# UNITED STATES PATENT AND TRADEMARK OFFICE

APPLICATION NO.	FILING DATE	FIRST NAMED INVENTOR	ATTORNEY DOCKET NO.	CONFIRMATION NO.
10/663,653	09/17/2003	Hideki Kanie	A-9923	3807

**Office Action Summary**

### **DETAILED ACTION**

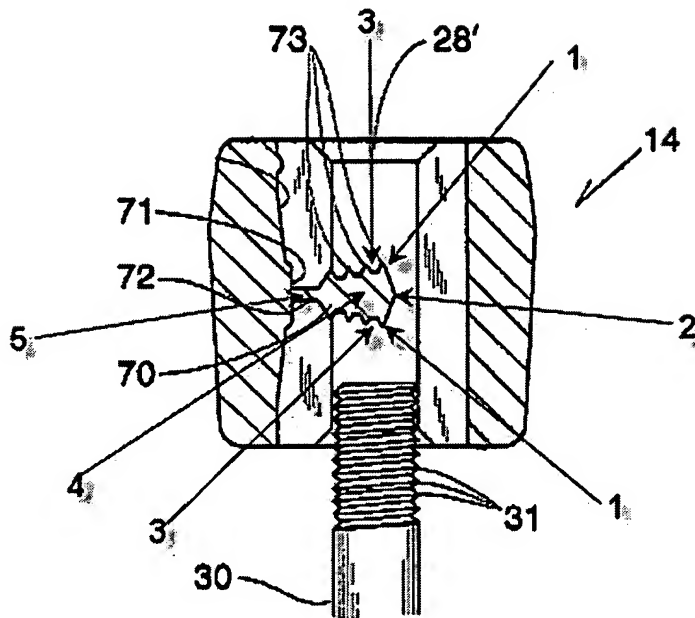
[5] Claims 1-13 are rejected under 35 U.S.C. 102(b) as clearly anticipated by Geiger, US-6,240,602, because the invention was patented or described in a printed publication in this or a foreign country, or in public use or on sale in this country more than one (1) year prior to the application for patent in the United States.

As for Claim 1, Geiger teaches (Fig. 15) (also see figure below) of a device (14) to be attached to a threaded stud (30), comprising a body having a bore (28') for insertion of a stud (30), wherein the device (14) has only a single pawl (70), and, in the absence of a stud (31) in the

bore (28'), the pawl (70) extends from an inner wall (71) of the bore (28') in a direction substantially perpendicular to an axis of the bore (28'), wherein the pawl (70) has a flexible thin section (5) connected to the inner wall (71) and a thick section (4) extending from the thin section (5), wherein the pawl (70) can be bent in opposite directions at the thin section (5) for mounting the device (14) on a stud (30) from two directions, wherein a single pair (1) of thread engaging sections (73) are formed at opposite sides of a tip end (2) of the thick section (4), one or another of the engaging sections (73) being disposed for entering a space between crests of threads (31) of a stud (30) depending on a direction of insertion of the stud (30) in the bore (28'), wherein a single pair of grooves (3) are formed adjacent to corresponding engaging sections (1) of the pawl (70), each groove (3) being disposed for receiving a crest of a thread (31) adjacent to the space between the crests, and wherein the thick section (4) of the pawl (70) between the grooves (3) and the thin sections (5) is devoid of thread engaging sections and grooves corresponding to thread engaging sections.

As for Claim 3, Geiger teaches (Fig. 15) (also see figure above) of a device (14) to be attached to a threaded stud (30), comprising a body having a bore (28') for insertion of a stud (30), wherein the device (14) has only a single pawl (70), and, in the absence of a stud (31) in the bore (28'), the pawl (70) extends from an inner wall (71) of the bore (28') in a direction substantially perpendicular to an axis of the bore (28'), wherein the pawl (70) has a flexible thin section (5) connected to the inner wall (71) and a thick section (4) extending from the thin section (5), wherein the pawl (70) can be bent in opposite directions at the thin section (5) for mounting the device (14) on a stud (30) from two directions, wherein a pair (1) of thread engaging sections (73) are formed at an end (2) of the thick section (4), one or another of the engaging sections (73) being disposed for entering a space between crests of threads (31) of a

stud (30) depending on a direction of insertion of the stud (30) in the bore (28'), wherein a length of the thick section (4) of the pawl (70) is substantially greater than a distance between the inner wall (71) and a stud (30) inserted in the bore (28'), and wherein after insertion of a stud (30) in the bore (28'), a centerline of the pawl (70) forms an angle substantially less than 90° from the centerline of the pawl (70) before insertion of a stud (30).

As for Claim 6, Geiger teaches (Fig. 15) (also see figure above) of a device (14) to be attached to a threaded stud (30), comprising a body having a bore (28') for insertion of a stud (30), and having only a single pawl (70) in the bore (28'), wherein the pawl (70) is connected by a hinge (5) to a first inner wall (72) of the bore (28'), wherein the pawl (70) has a centerline extending in a first direction substantially perpendicular to an axis of the bore (28') before insertion of a stud (30) in the bore (28') and forming an angle of substantially less than 90° with respect to the first direction after insertion of the stud (30) in the bore (28'), and wherein the pawl (70) has a thread engaging section (73) at a pawl tip (2) that enters a space between successive crests of threads (31) of a stud (30) and has an adjacent groove (3) that receives one of the crests of the thread (31), wherein the pawl (70) has a length (via 4) between the groove (3) and the hinge (5) that is devoid of thread engaging sections and thread crest receiving grooves, and wherein a second inner wall (inside 22) of the bore (28') is constructed to minimize lateral

Geiger. A figure has been provided (see above) to help show that the structure of Geiger does indeed anticipate that of the claims. It is the claims that define the claimed invention, and it is claims, not specifications that are anticipated or unpatentable. *Constant v. Advanced Micro-Devices Inc.*, 7 USPQ2d 1064. Applicant states that Geiger does not teach of a single pair of thread engaging sections formed at opposite sides of a tip end of the thick section and a single pair of grooves formed adjacent to corresponding engaging sections. The examiner disagrees. Geiger does indeed disclose of a single pair (1) of thread engaging sections (73) formed at opposite sides of a tip end (2) of the thick section (4) and a single pair of grooves (3) formed adjacent to corresponding engaging sections (1) (73) (see figure above). Applicant goes on to state numerous other features from the applicants claimed invention that he believes is not anticipated by the structure of Geiger. Examiner disagrees, and directs the applicant once again to the claim rejection section above where it is distinctly shown how each and every claimed element is disclosed and anticipated by the structure of Geiger.
